**Subject:** FW: BN-16-0065 exterior permit

1515 UNIVERSITY AVE.  
CHARLOTTESVILLE, VA

Lloyd Building Roof  
Replacement Description  
(1515 University Avenue)

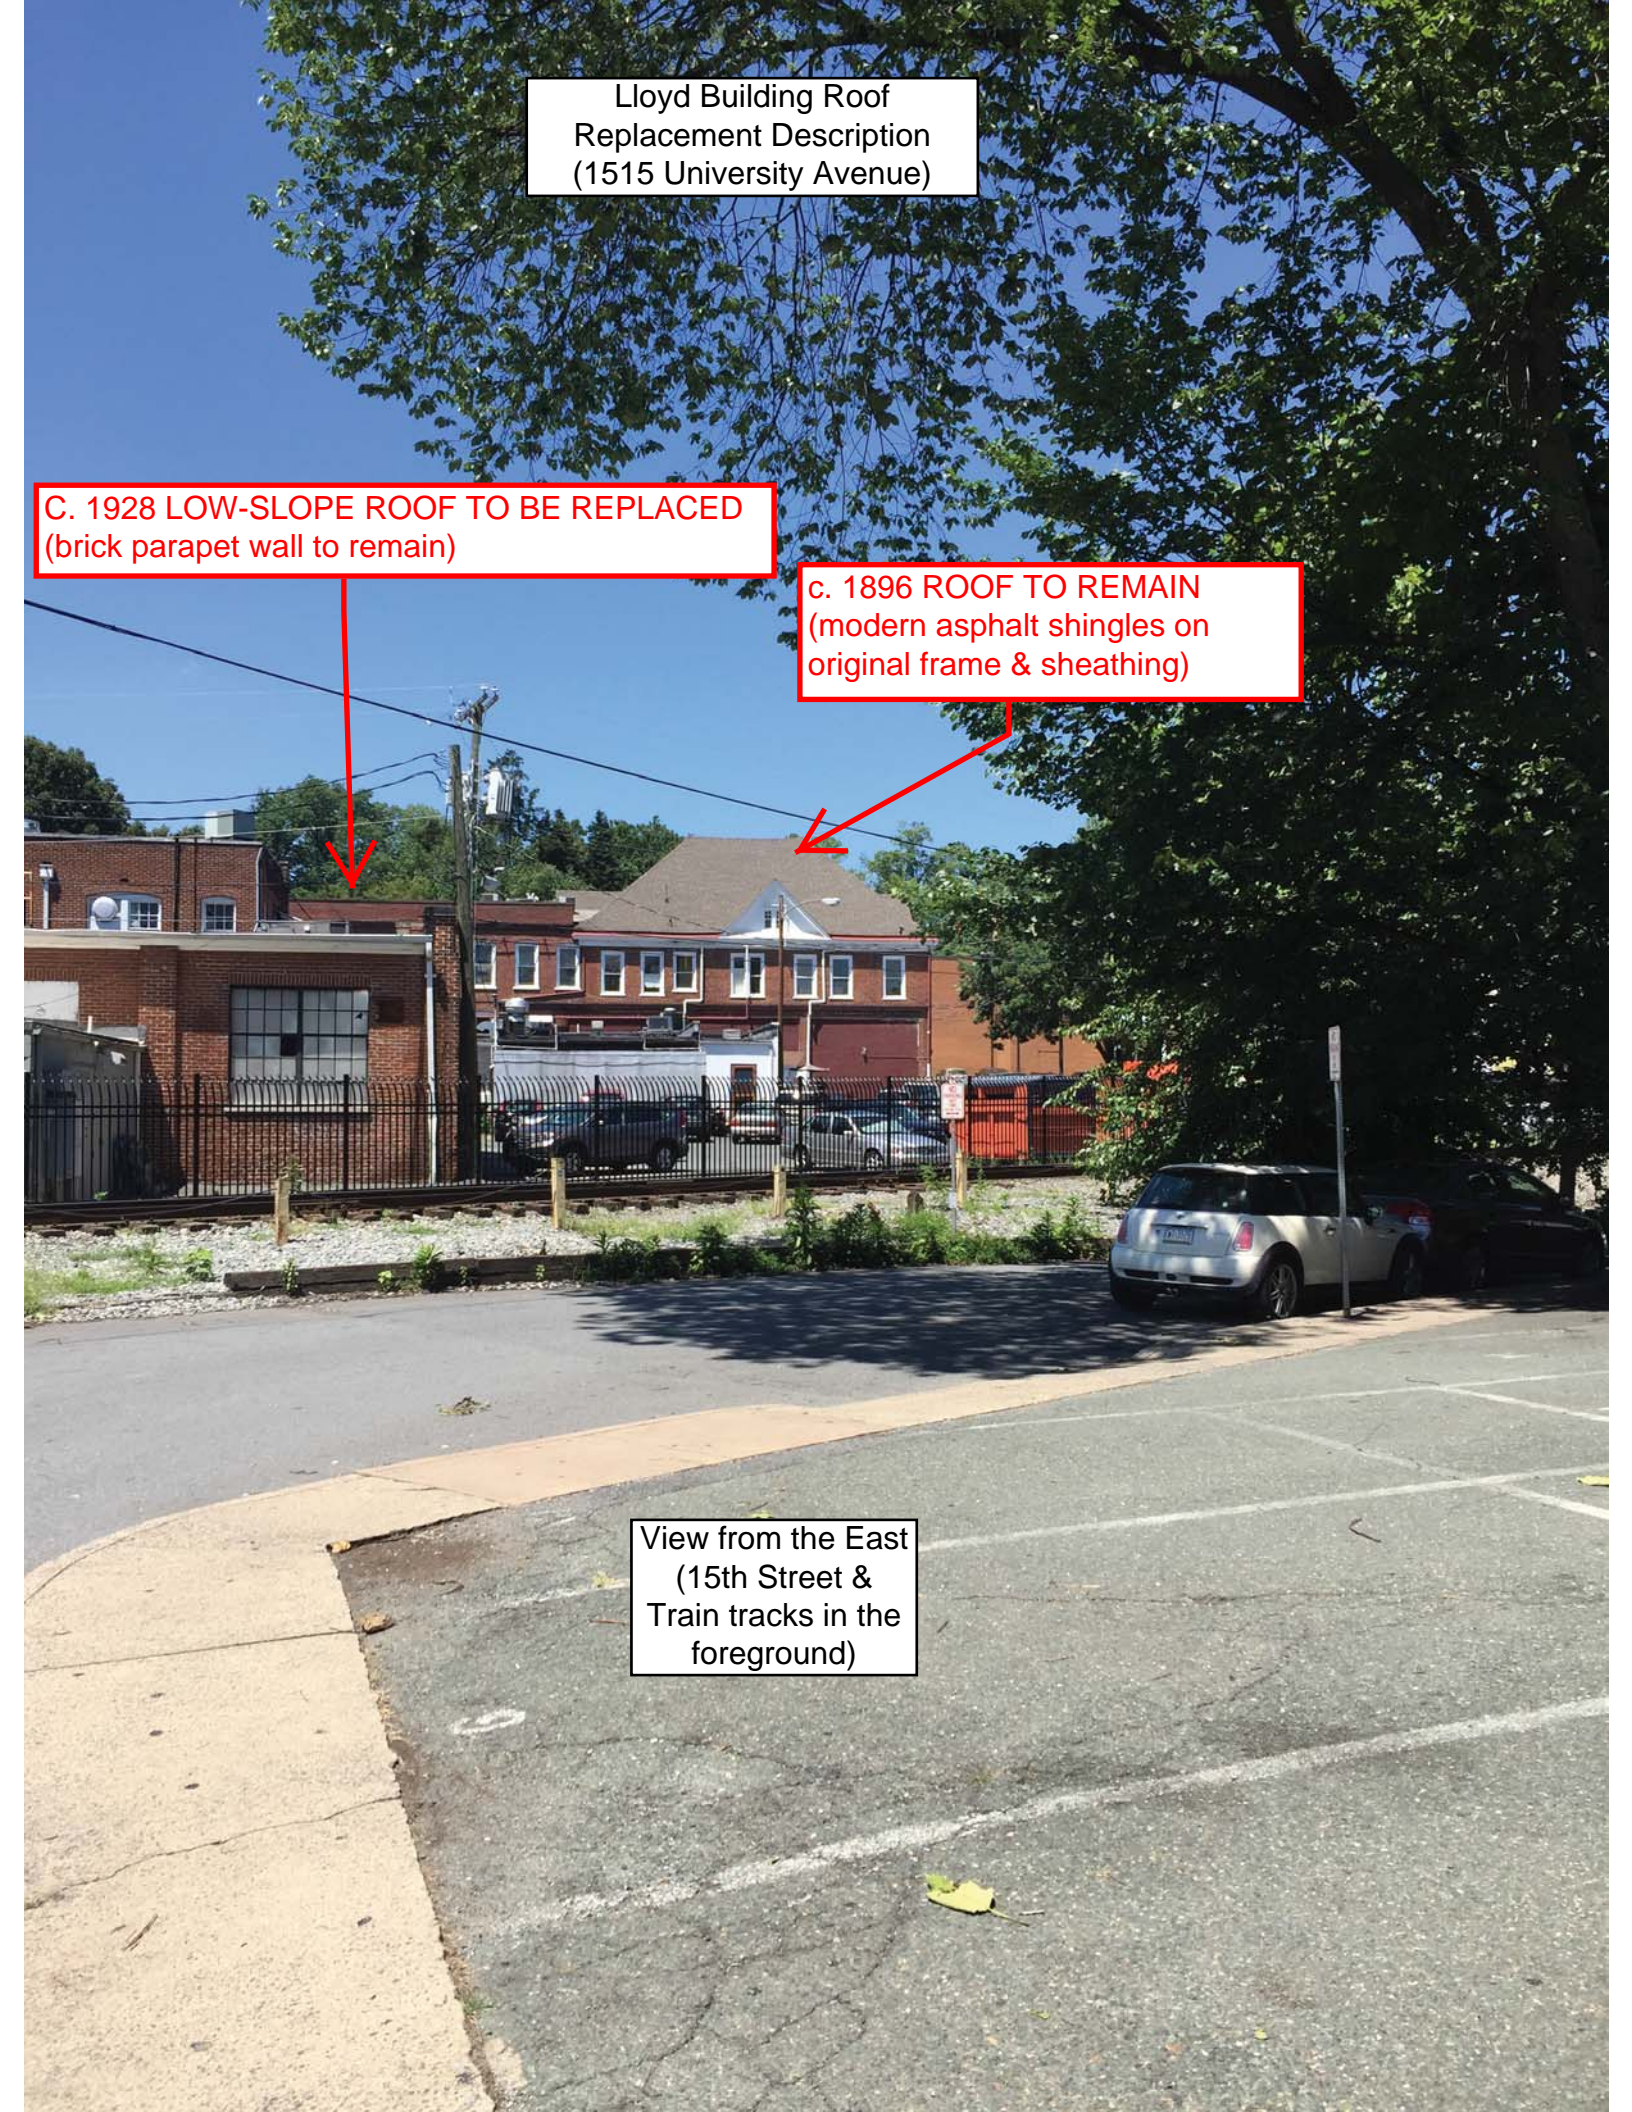
One last question- will the appearance of the parapet wall (cap) change?

The BAR was not aware the roof would be replaced. If there is a change in material or design from existing then the BAR needs to review.

The plans call for replacing the existing sheet metal wall cap. We'll be sure to match existing profiles, color, etc. There is a small projection of the top brick course, which we will maintain as well.

- 1) Yes, it is our intention to match the existing exterior paint color for the wooden trim (white).
- 2) We are planning to replace *only* the low-slope section of roof that is hidden behind the brick parapet wall. This roof is over the 1927/28 commercial addition to the building, and is currently covered by an asphaltic coating. Our plan is to replace it with a new rubber membrane roof which, like the existing, is not visible from the ground. The existing hip roof atop the original 1896 house will remain. I have attached some photos to help explain the roof work.

C. 1928 LOW-SLOPE ROOF TO BE REPLACED  
(brick parapet wall to remain)

c. 1896 ROOF TO REMAIN  
(modern asphalt shingles on  
original frame & sheathing)
